LISTING OF CHANGES TO DRB APPROVED SITE PLAN DATED 02-15-01

ADMINISTRATIVE 1000937
 DEVELOPMENT PLAN AMENDMENT
 FILE NO. AA-03AM-01290
 Meeting SDP: 29.07; 11/14/03
 Scheduling: Day Red, Land, R.O.
 Planning Director DATE

**CITY OF ALBUQUERQUE
 CAPITAL IMPLEMENTATION PROGRAM**

TITLE: W.S.T.F. REVISED SITE PLAN

CITY PROJECT NO. 5658.01 ZONE MAP NO. J-9-Z SHEET S1-A-101 OF 000

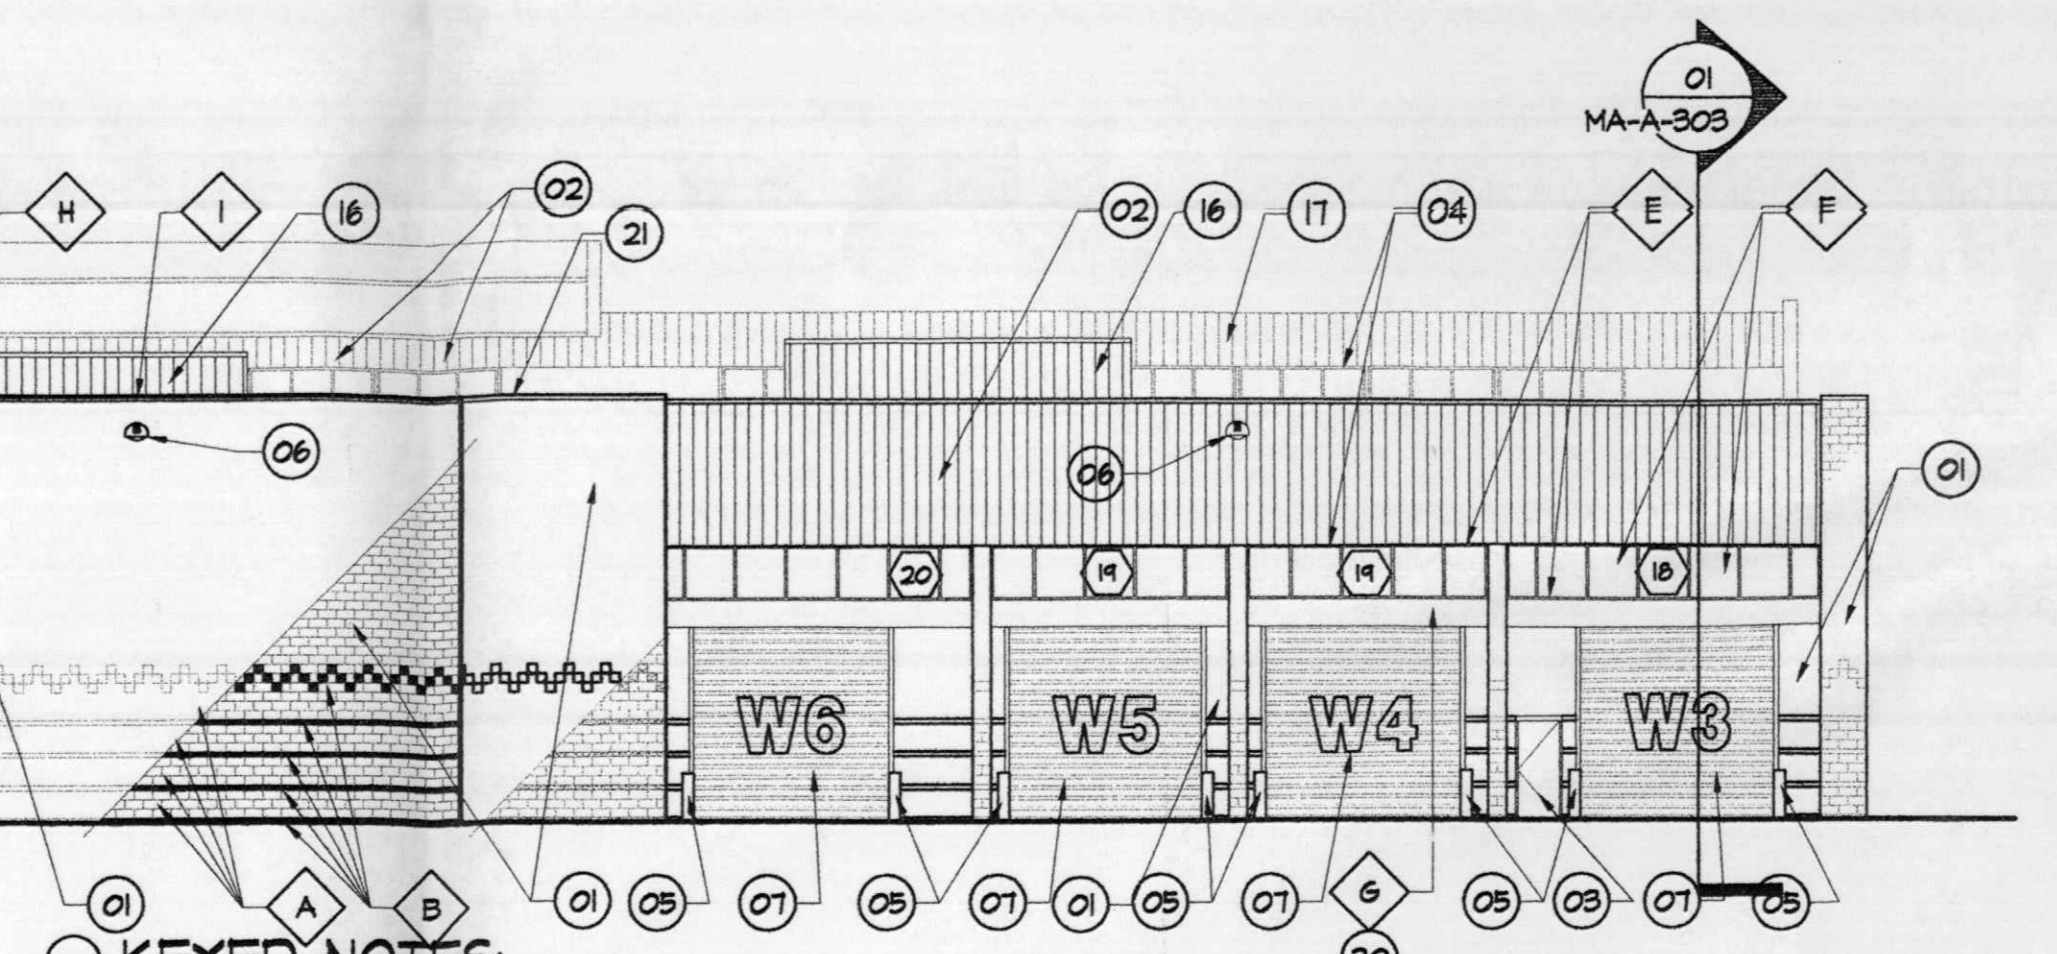
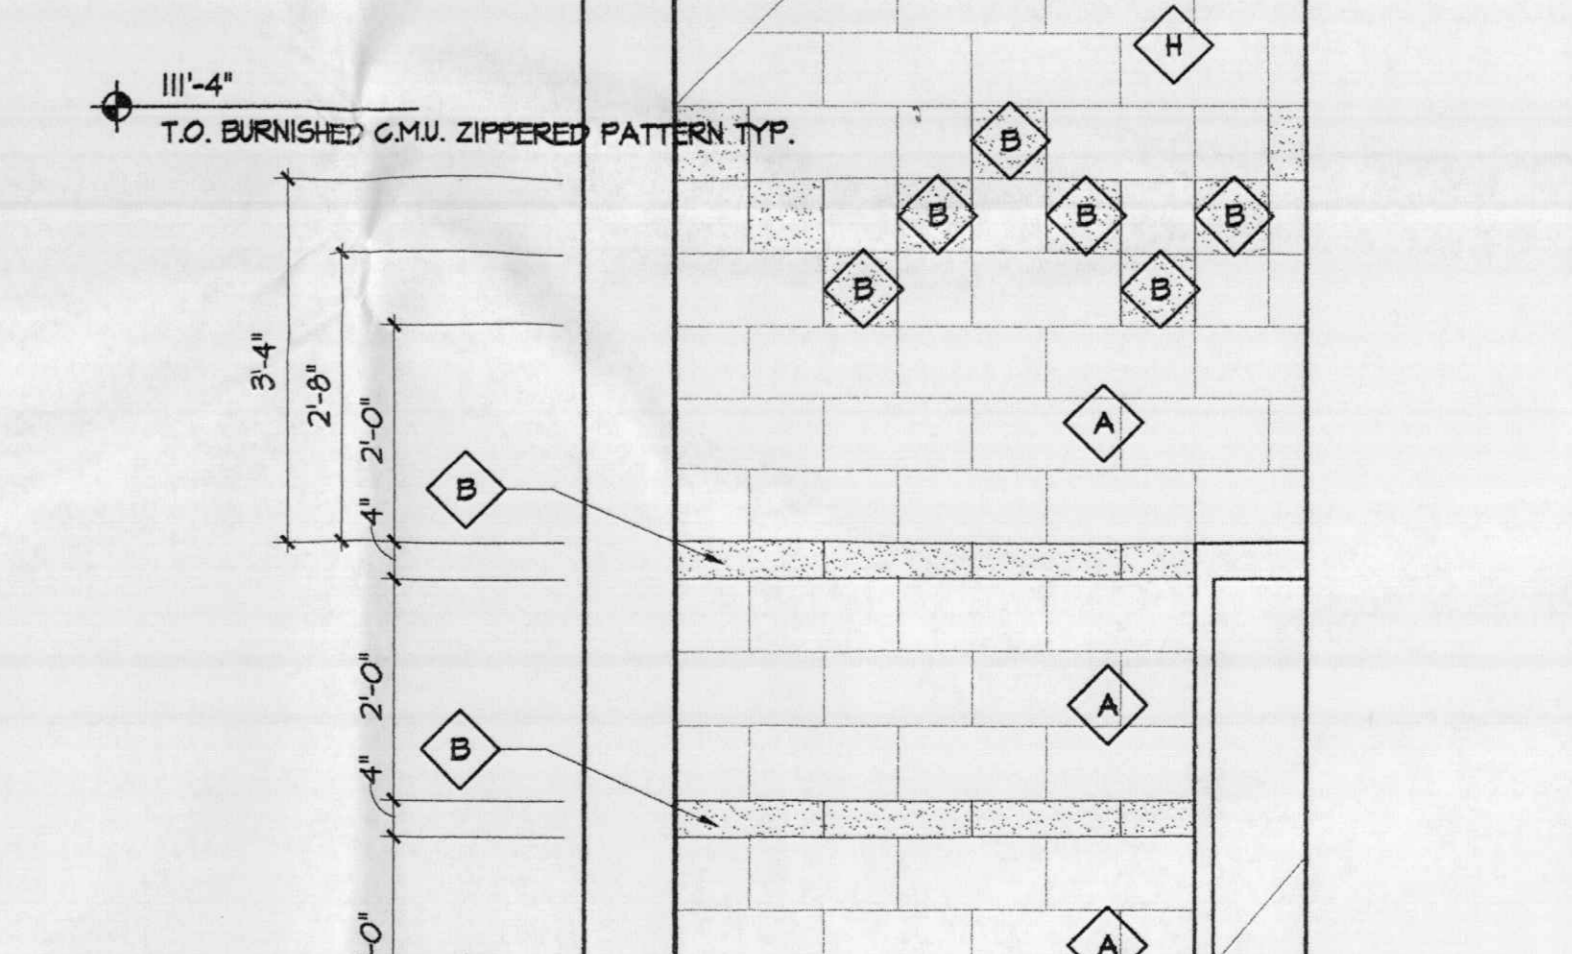
- * RETAINING WALL SHIFTED TO WEST 28'-2".
- * MAINTAINANCE BLDG. SHIFTED TO WEST 32'-11" & TO SOUTH 11'-0". ADDED 10,448 S.F.
- * OPERATION BLDG. SHIFTED TO WEST 93'-9" & TO SOUTH 10'-0". ADDED 1,329 S.F.

- * BUS STORAGE BLDG. SHIFTED TO WEST 12'-5" & TO SOUTH 20'-4". REDUCED IN LENGTH 71'-4". REDUCED IN SIZE 12,956 S.F.
- * WASH BLDG. REMAINED AT ORIGINAL LOCATION BUT ADDED ON FUTURE BAY ON SOUTH SIDE. MAKE PROVISION FOR WATER CONSERVATION & BOILER ROOM ADDITION ON NORTH SIDE.

- * FUELING BLDG. REMAINED IN ORIGINAL LOCATION BUT ADDED FUTURE BAY ON SOUTH SIDE.
- * CONTROL BLDG. SHIFTED TO SOUTH 61'-9". NO CHANGE IN SIZE.
- * CHANGED PARKING S.E. OF OPERATION BLDG. TO DOUBLE LANE OF DIAGONAL PARKING & SHIFTED LOCATION TO WEST 93'-9".

- * DAY CARE BLDG. IS SAME AS ORIGINAL 9500 S.F.
- * REDUCED SIZE OF OUTDOOR ACTIVITY AREA FROM 11325 S.F. TO 9099 S.F. (EXCEEDS DAY CARE REQUIREMENTS)
- * REDUCED ADJACENT DAY CARE PARKING DROP OFF FROM 22 SPACES TO 8 SPACES. (DAY CARE STAFF PARKING MAY BE ACCOMMODATED IN PARKING S.E. OF OPERATION AND/OR STAFF PARKING.)

- * ADDED FUTURE VAN STORAGE BLDG. LOCATION. (SIZE TO BE DETERMINED AT FUTURE DATE)
- * STAFF PARKING REDUCED FROM 342 TO 294 (3 SHIFTS OF STAFF PARKING WAS ERRONEOUSLY ADDED TOGETHER RATHER THAN 2 FOR OVERLAP OF PARKING)
